KIM User manual Errata Sheets and Application Notes

ERRATA SHEET #1

KIM-1
Errata Sheet #3

KIM-1 APPLICATION NOTE #1

UNLESS OTHERWISE SPECIFIED DIMENSIONS ARE IN INCHES FRACTIONS DECIMALS ANG + + + - - -	APPROVAL	DATE		
	ENG			
	DWN		TITLE 1MS "FALSE START" ELIMINATOR	
MATERIAL: 4 RESISTORS 1 CAPACITOR 2 DIODES (1N4001) 1 IC (LM 556)	CHX'D		SIZE	DRAWING NO.
	APPROVED		A KIM	
			SCALE	SHEET OF

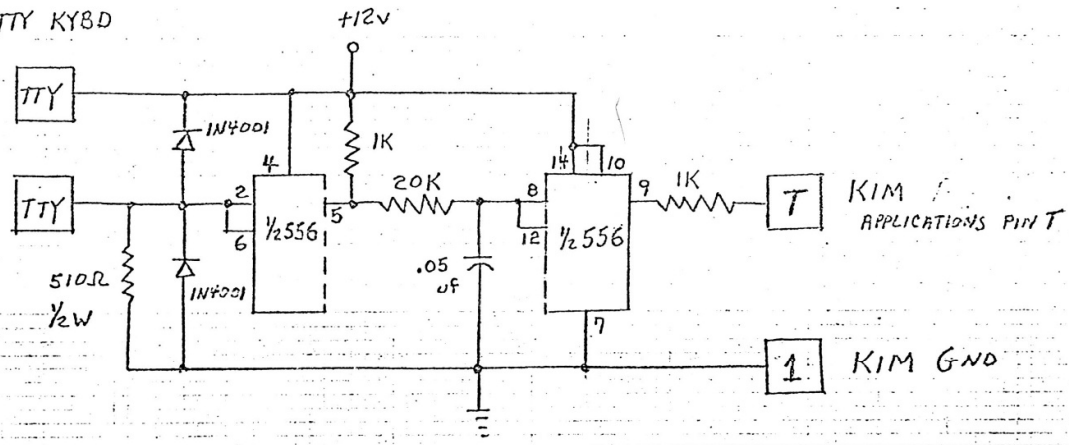
- Page C-2 - in the fourth line from the top, change to Pin A-P (not A-B).
- Page 74 - the schematic of Fig. 6.2 should be changed to show a more commonly available non-inverting line receiver. Also, the connections to the decoders (74145) should be corrected as shown in the diagram on the following page:
